# UNITED STATES PATENT AND TRADEMARK OFFICE

APPLICATION NO.	FILING DATE	FIRST NAMED INVENTOR	ATTORNEY DOCKET NO.	CONFIRMATION NO.
10/507,450	04/07/2005	Mark Patrick	4623-045154	3051
7590		01/18/2008		
Richard L. Byrne				
700 Koppers Building				
436 Seventh Avenue				
Pittsburgh, PA 15219-1818				
			EXAMINER	
			CAJILIG, CHRISTINE T	
			ART UNIT	PAPER NUMBER
			3633	
			MAIL DATE	DELIVERY MODE
			01/18/2008	PAPER

<p align="center"><b>Office Action Summary</b></p>	<b>Application No.</b> 10/507,450	<b>Applicant(s)</b> PATRICK, MARK	
	<b>Examiner</b> CHRISTINE T. CAJILIG	<b>Art Unit</b> 3633

Platano '399

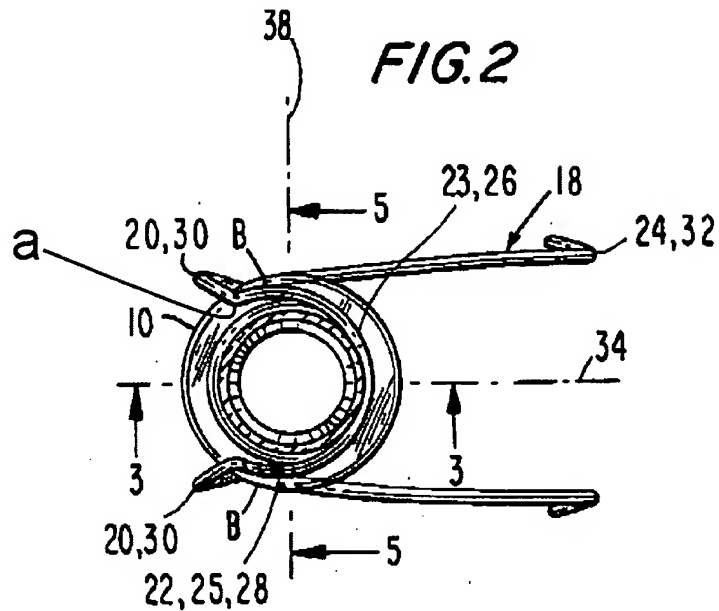
Regarding claim 30, Platano in Figures 1-6 discloses a clip capable of being used with the connector assembly defined in claim 1 and includes a means (24) *for coupling the clip to a section of the connector element*, and a plurality of legs (22) formed from resilient material that extend inwardly and have inner ends that describe an opening (defined by 26) *that can receive a section of the connector, and which opening has a diameter that is less than that of the connector section, whereby in use the legs deflect when the clip is pushed over the connector so that the connector section extends through the opening and the inner ends of the legs contact the connector section and thereby couple the clip to the connector*.

Regarding claim 33, Platano discloses the structure discussed above and further discloses that at least one of the legs includes an upward crank (30).

Regarding claim 34, Platano discloses the structure discussed above and further discloses that the leg or legs that include the cranked end further include a section (a) that is formed to increase the flexibility of the leg.

Regarding claim 37, Platano discloses the structure discussed above and further discloses that the inner ends of the legs include projections (that form curved portion 26) *that enable the legs to grip the connector section securely.*

Regarding claim 39, Platano discloses the structure discussed above and further discloses that the means for coupling the clip to the section of the connector element includes a plurality of clasps (downwardly hooked portion of 24, 32) that *can inherently clip onto the section of the connector element*.
